# City of Richmond

## Report to Committee Planning and Development Department

**Re:** Application by Yamamoto Architecture Inc. for Rezoning at 10591, 10611 and 10631 Gilbert Road from Single Detached (RS1/E) to Low Density Townhouses (RTL4)

WITH:  
 TAMAMOTO ARCHITECTURE INC.  
 DRAWING TITLE:  
**LANDSCAPE PLAN**

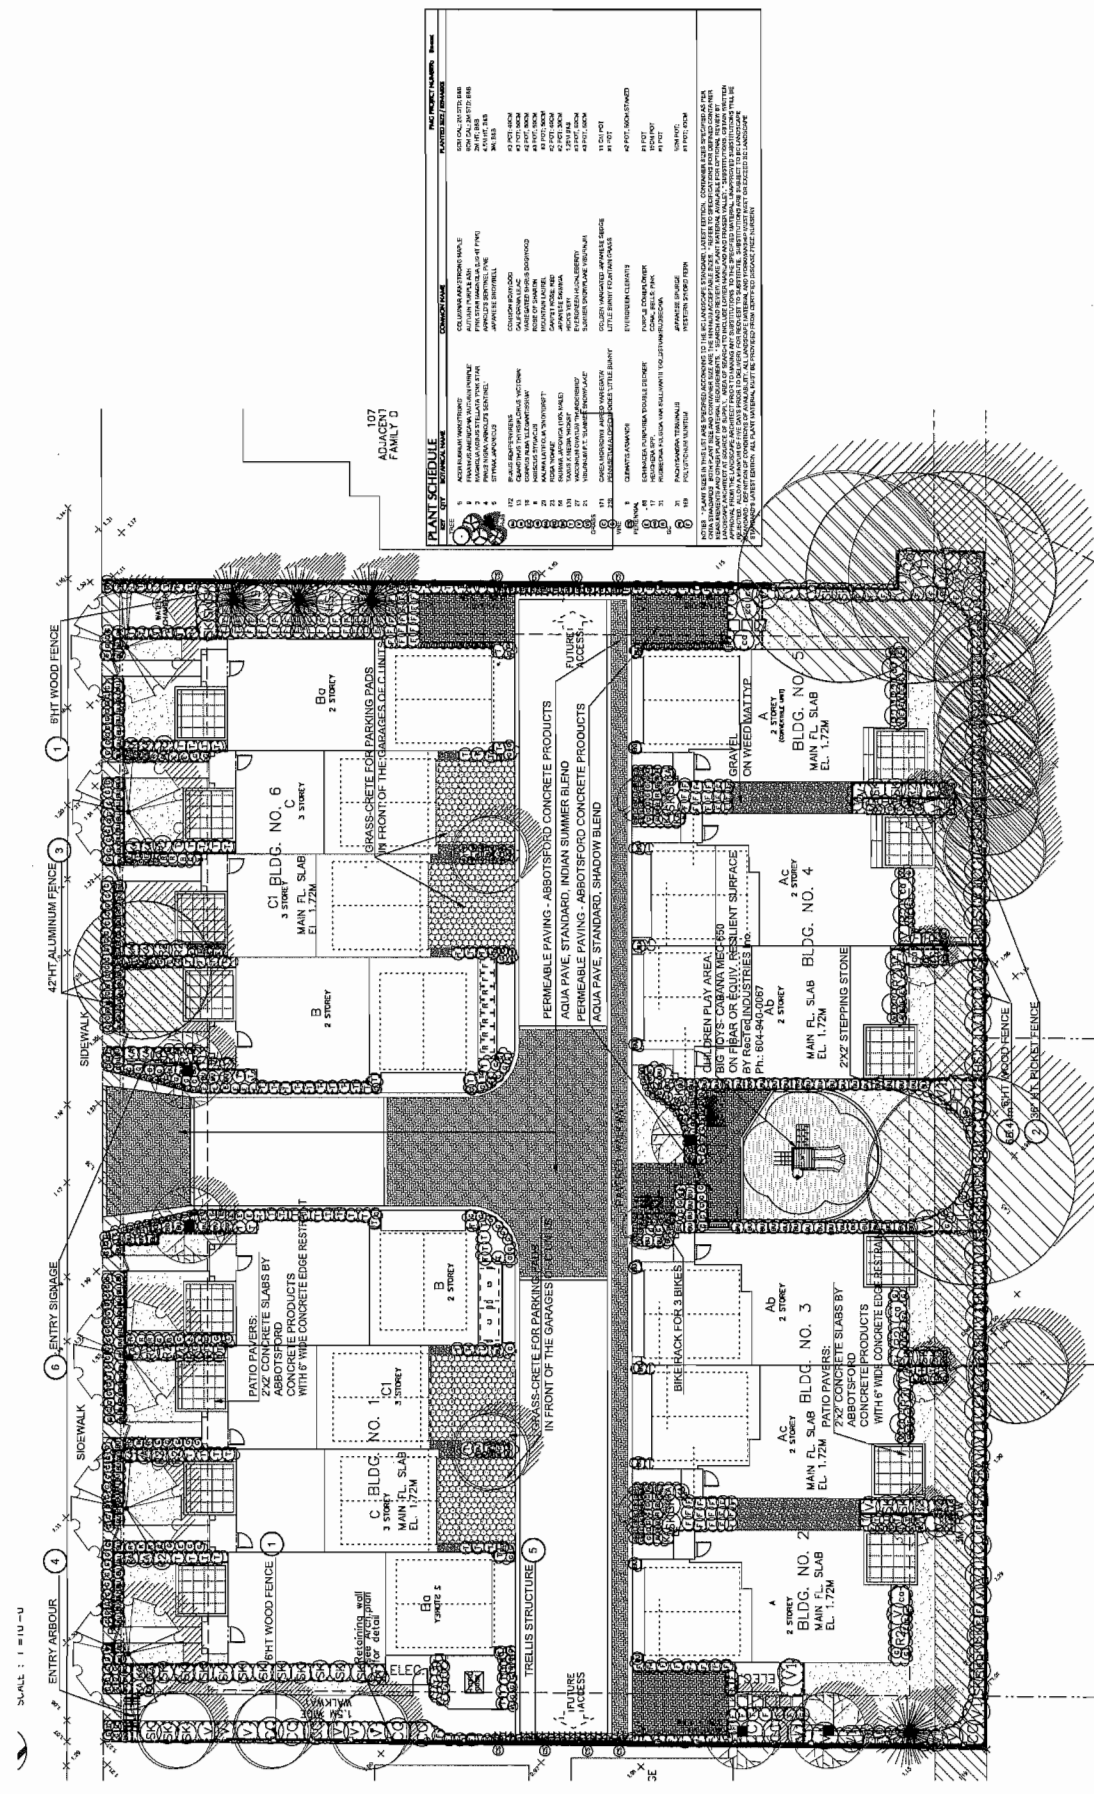
Based on the 2:1 tree replacement ratio goal stated in the Official Community Plan (OCP), 70 replacement trees are required for the removal of 35 trees on site. According to the Preliminary Landscape Plan (Attachment 2), the developer is proposing to plant 26 new trees

on-site; size and species of replacement trees and overall landscape design will be reviewed in detail at the Development Permit stage. The applicant has agreed to provide a voluntary contribution of \$22,000 to the City's Tree Compensation Fund in lieu of planting the remaining 44 replacement trees should they not be accommodated on the site.

WITH: YAMAMOTO ARCHITECTURE INC.  
DRAWING TITLE: TREE MANAGEMENT PLAN

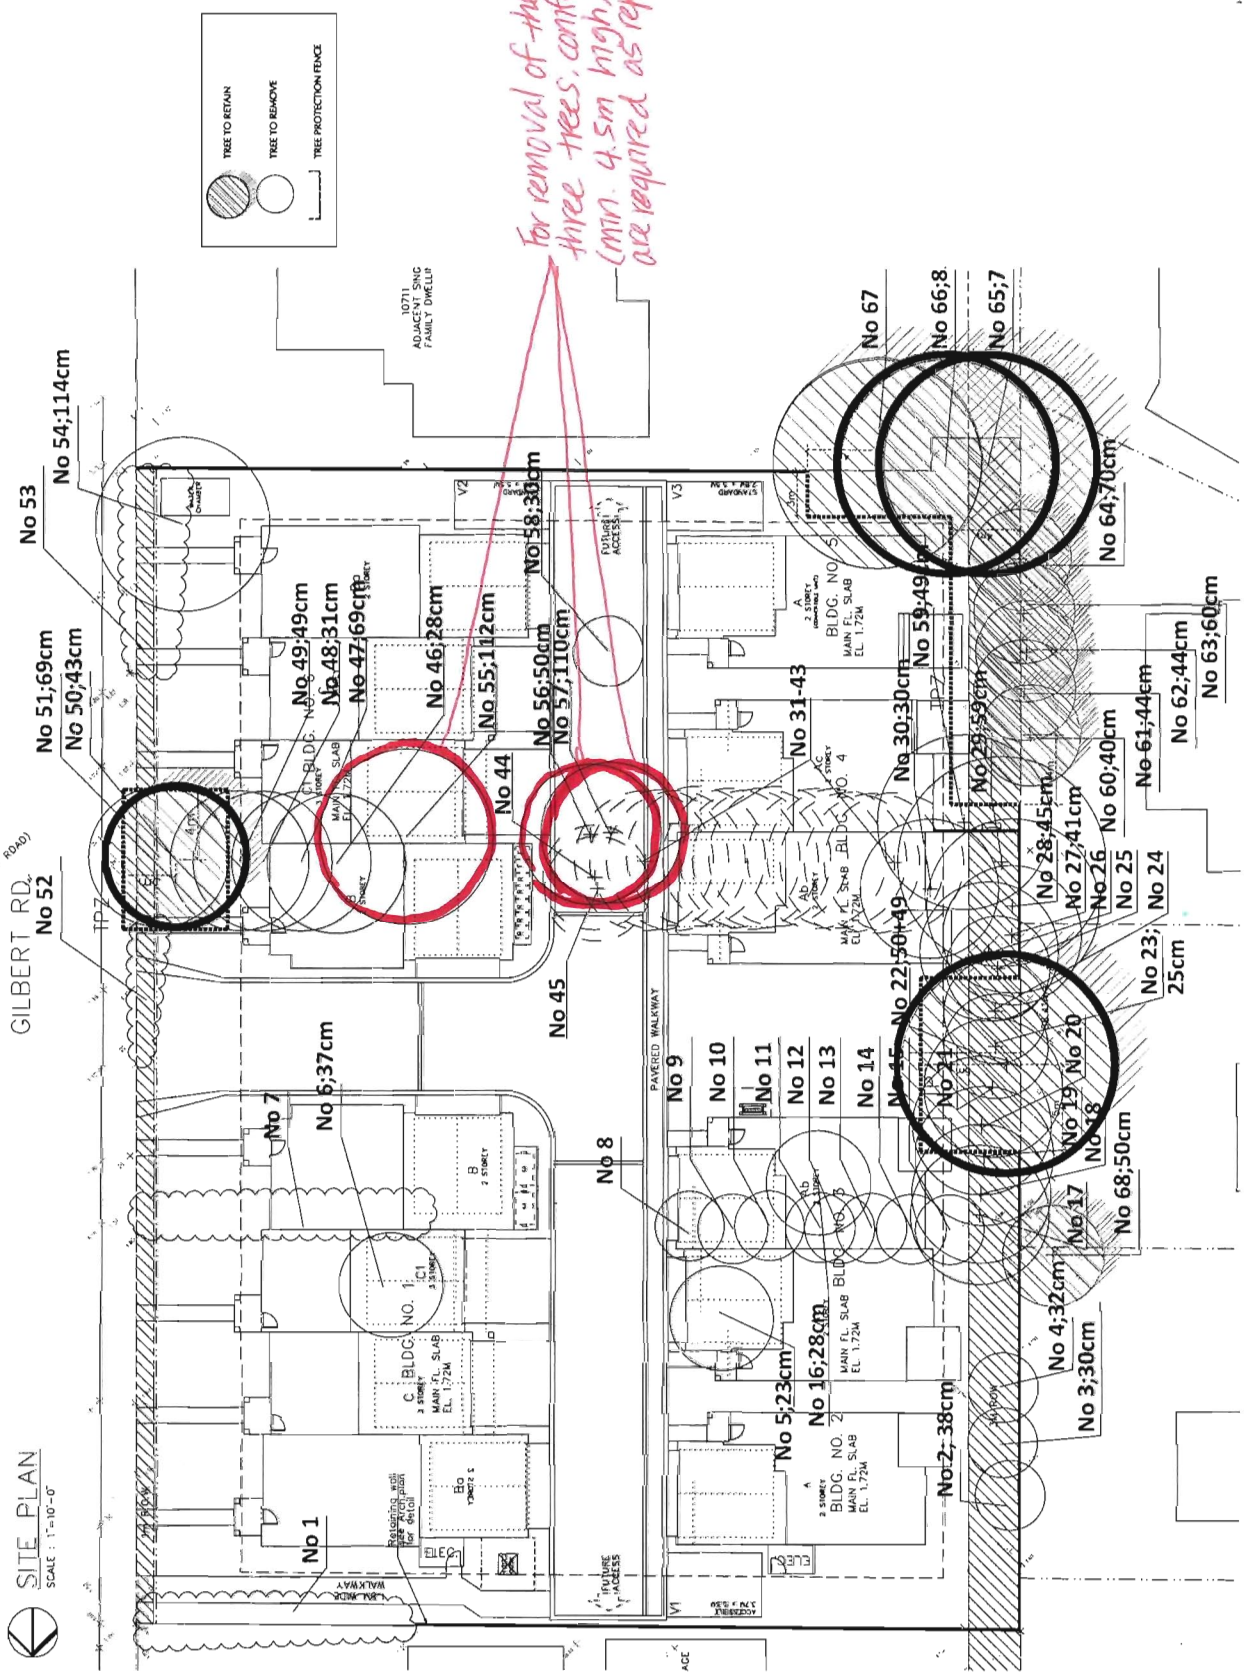
- A total of 57 on-site trees are identified on the survey; however, the vast majority of the trees comprise hedgerows (a "hedgerow" is a row of closely planted trees used to delineate a property line or provide a visual screen).

- For the purpose of determining the number of required replacement trees, staff have determined that small groups of trees that comprise hedgerows can be considered as single trees. Based on this, there are 39 trees on the site.

- Four (4) trees, Sycamore Maple (tag# 22), Hemlock (tag# 50), two Douglas Fir trees (tag# 65 and 66), are in good condition and are to be retained and protected (Attachment 4).

- Seven (7) neighbouring trees, specifically tag# 60, 61, 62, 63, 64, 67 and 68, are to be retained and protected.
- Four (4) remnant Cedar hedges, identified as tag# 1, 7, 52 and 53, have marginal landscape value and should be removed.

- Three (3) trees, a Pine (tag# 55) and two Cedar trees (tag# 56 and 57), are in fair condition but located in the middle of the site (i.e. on the proposed drive aisle or within the building envelope). In order to successfully retain these trees, four (4) units would need to be eliminated from the proposal. Removal and replacement with conifer (minimum 4.5 m high) is recommended. The applicant has agreed to provide conifers (minimum 4.5 m high) as replacement trees and is required to show them on the Development Permit drawings.

- 32 trees located on site have been previously topped or have significant dieback and/or sparse canopies. As a result, these trees are not good candidates for retention and should be replaced.

A Tree Management Plan can be found in Attachment 4.
